INFORMATIONAL FIELD SERVICE BULLETIN

FSB Number	CHRAEFSB2015-71
Author	Tony Bryan
Date	11/10/2015
Subject	XT1585 Droid Turbo 2 - SIM Tray - Detached End-Cap
Model Affected	XT1585 Droid Turbo 2
Level Of Repairs	Level 1

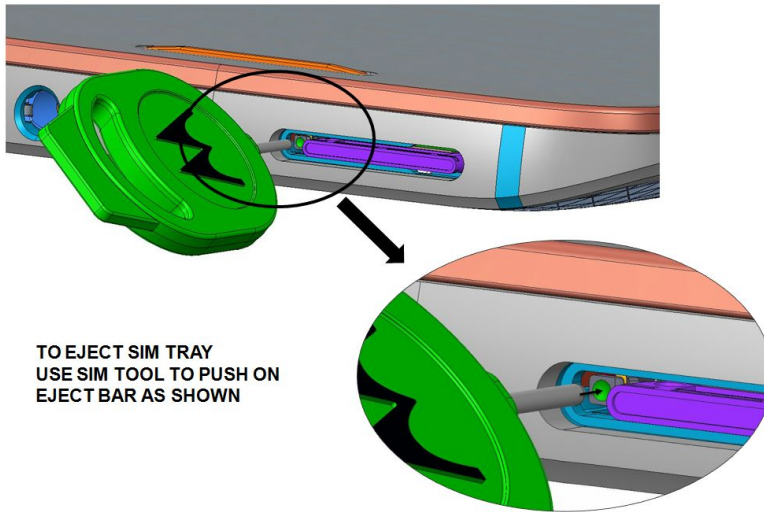
Motorola is aware of a potential field return issue on the Droid Turbo 2 product related to SIM Tray. Design verification testing identified an issue where excessive force from drop could cause the End-Cap to detach from the SIM Tray.

Motorola implemented changes to the SIM Tray, at both suppliers, to resolve this issue. See image below:

Supplier A (P/N: 01018377007/8/9) - Rev E or later
Supplier B (P/N: 01018377107/8/9) - Rev B or later

- Purge/Scrap any existing inventory of older SIM Trays
 - Supplier A (P/N: 01018377007/8/9) - Rev D or earlier
 - Supplier B (P/N: 01018377107/8/9) - Rev A or earlier
- Stock only newer SIM Trays
 - Supplier A (P/N: 01018377007/8/9) - Rev E or later
 - Supplier B (P/N: 01018377107/8/9) - Rev B or later
